PRM-50-95
(75FR66007)

Subject: Industry Comments on Petition for Rulemaking (PRM-50-95), NRC Order Vermont Yankee to Lower the Licensing Basis PCT. Docket ID NRC-2009-0554

Industry Comments on Petition PRM-50-95

Figure 1 - PCT evolution of a rod due to decaying and two-sided oxidation heat assuming different cooling rates (heat transfer coefficients).

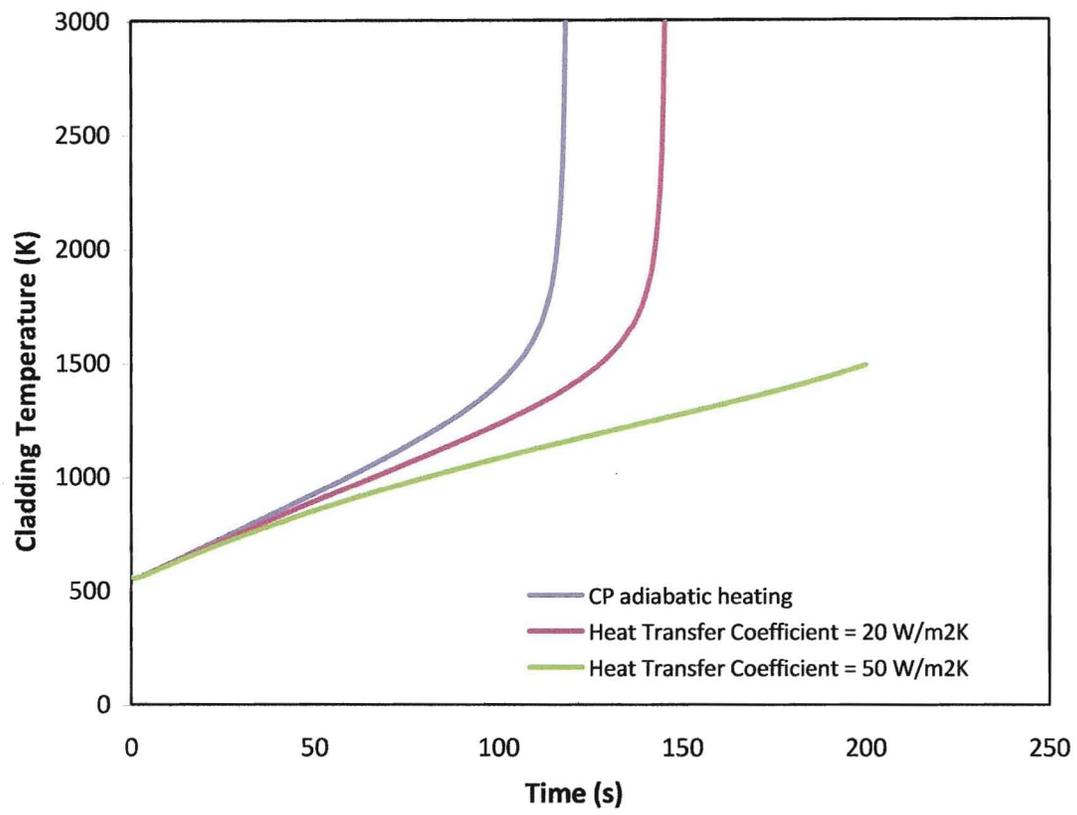
The effect of heat balance, expressed in terms of heat transfer coefficients, on accelerated oxidation is illustrated in a case study shown in Figure 1. In this evaluation, double sided Cathcart-Pawel correlation was used for the metal-water reaction. Clearly with a heat transfer coefficient of ~ 20 W/m²K the reaction is autocatalytic and cannot be stopped. This is comparable to what happens in the severe accidents tests, since the test objective is to melt the rods. However, with a heat transfer coefficient of ~ 50 W/m²K, a rate significantly lower than what is calculated in realistic LOCA case, the reaction is not autocatalytic and temperatures above 2200°F (1204°C) can be reached without oxidation runaway. This demonstrates that the escalation of cladding temperature is a function of the balance between heat generation and removal. This is reinforced from calculations conducted in support of the Quench-06 test [2]. The maximum calculated bundle temperatures calculated in the simulated Quench-06 experiment are presented in Figure 2. This experiment showed that with the proper heat balance it is possible for the cladding to attain high temperatures without approaching runaway oxidation (until the power transient was initiated after 6000 seconds).
